McClellan Air Force Base

Davis Global Communications Site

Remedial Investigation/ Feasibility Study Report

SUBJECT: Final Copy, Remedial Investigation/Feasibility Study (RI/FS) Report, Davis Global Communications Site

FIGURE B-2
AIR PERMEABILITY TEST AT CH-4
DAVIS GLOBAL COMMUNICATIONS SITE
McCLELLAN AIR FORCE BASE

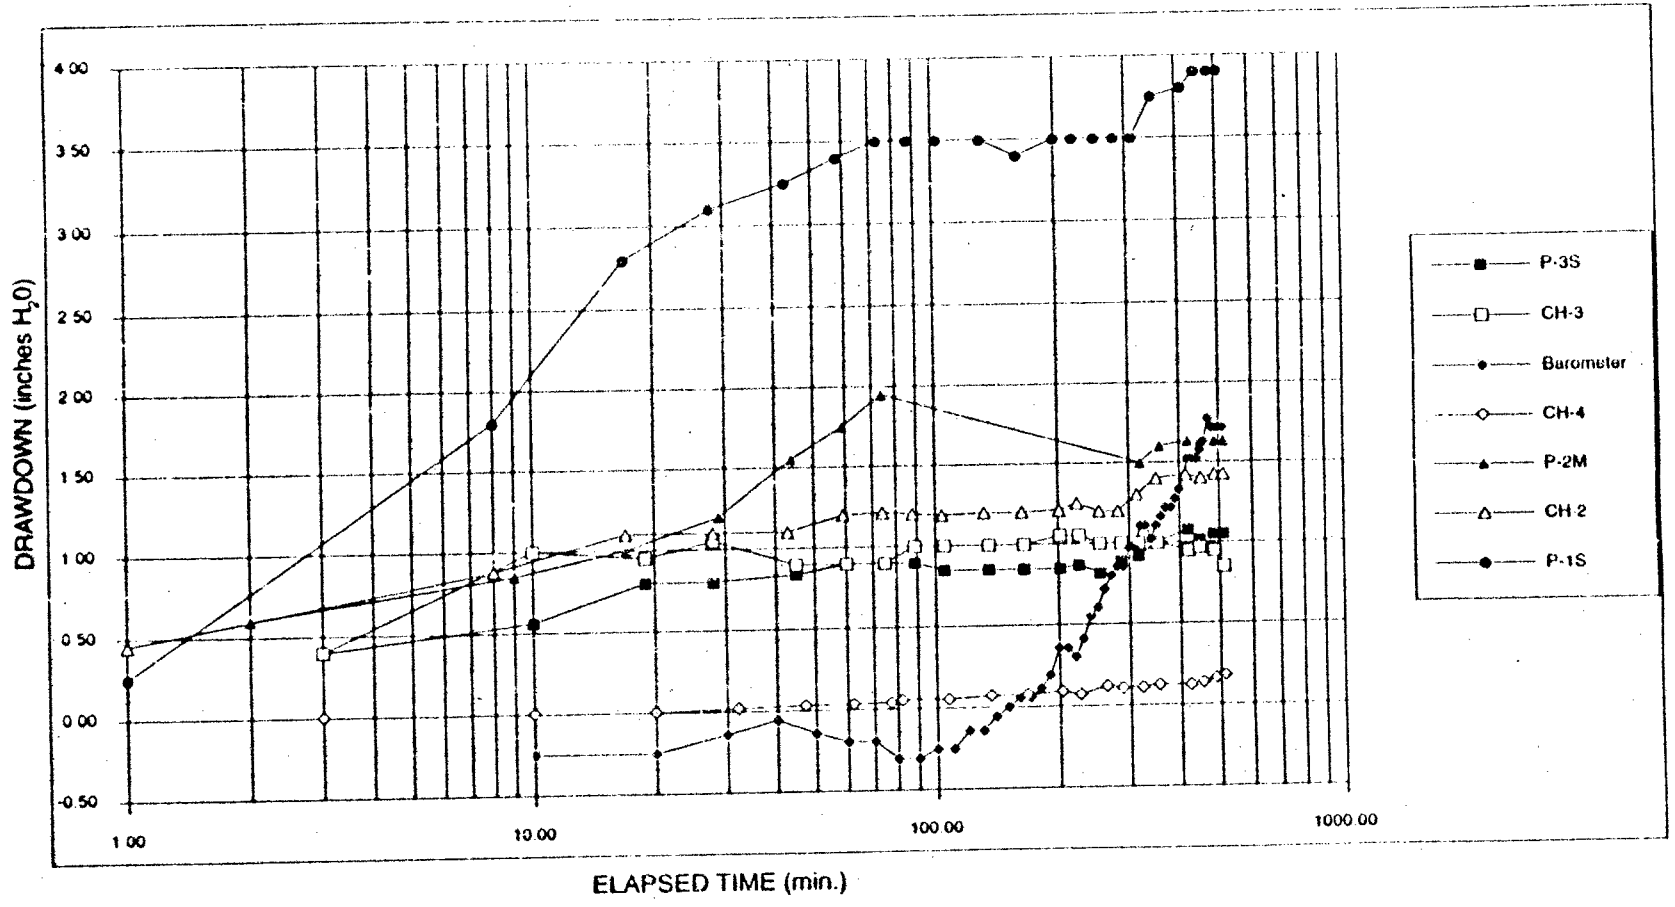
2. **Figure B-2. The response of the SVMWs and piezometers are suspiciously matched to the barometric pressure. Can you provide any insight to the correlation? The data for the air permeability tests at CH-1 and 5 do not appear to correlate as closely.**

FIGURE J-19
OPERATION SCHEMATIC FOR EXTRACTION SYSTEM
DAVIS GLOBAL COMMUNICATIONS SITE
McCLELLAN AIR FORCE BASE
YOLO COUNTY, CALIFORNIA

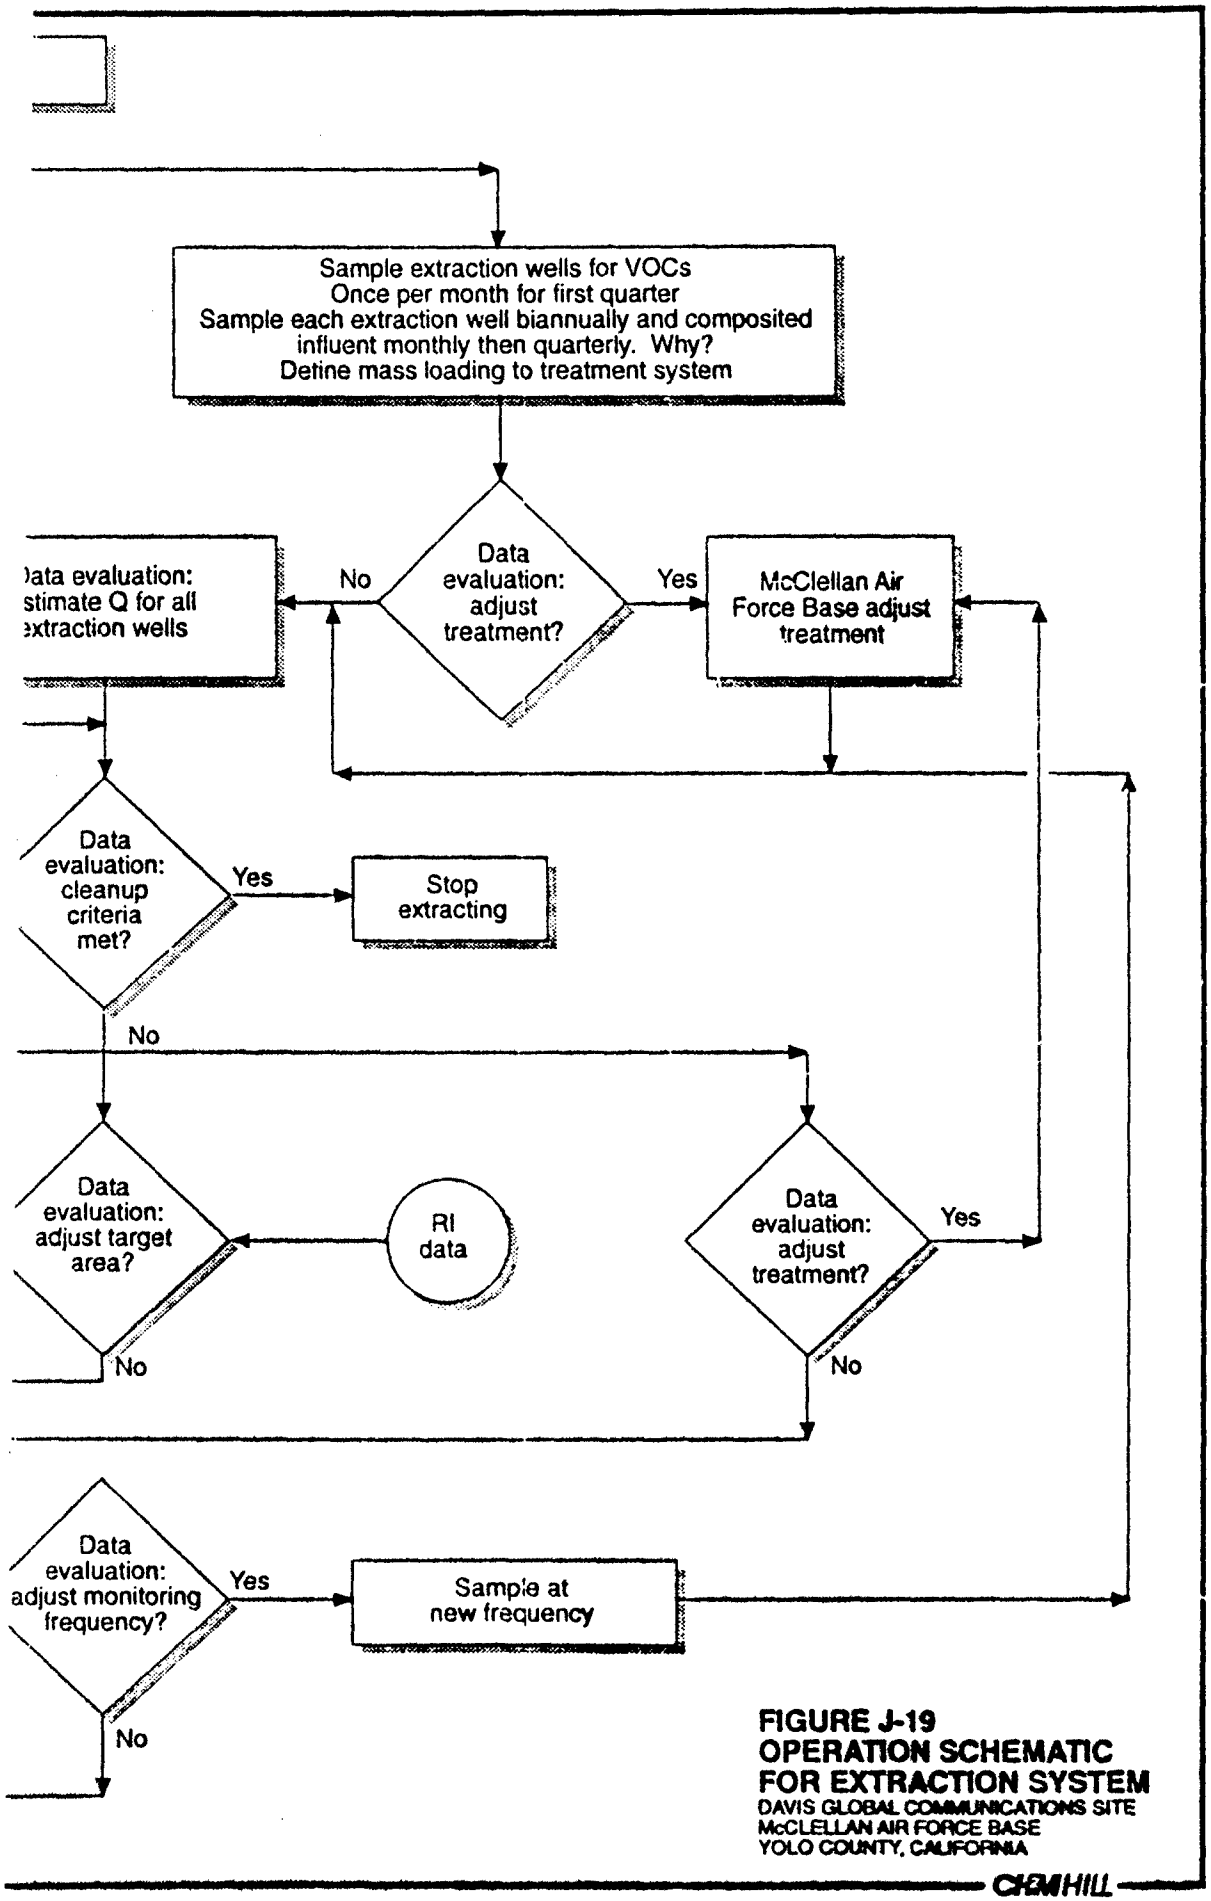
10. **Appendix J, Figure J-19. The first decision diamond on the right side of the flow diagram does not have a "Yes" path associated with it. Two other decision diamonds have two arrows leading from them but only the "no" path is delineated.**

9. **Figure J-19. AG pumping Diamond - Define a time period (i.e. 2-3 weeks). Adjust Q Box - It may not be necessary to adjust "all" well(s). The logic for the two "Adjust Target Area" Diamonds is not clear. What is the difference between the McAFB adjust treatment box and the previous adjust treatment decision diamond and why does the McAFB adjust treatment box lead into another adjust treatment diamond? The "No" direction "clean-up criteria met?" diamond, should flow to all three decisions, "adjust target area?", "adjust treatment?" and "adjust monitoring frequency?". After the first quarter, how often will influent be sampled?**

10. Appendix J, Figure J-19. The first decision diamond on the right side of the flow diagram does not have a "Yes" path associated with it. Two other decision diamonds have two arrows leading from them but only the "no" path is delineated.
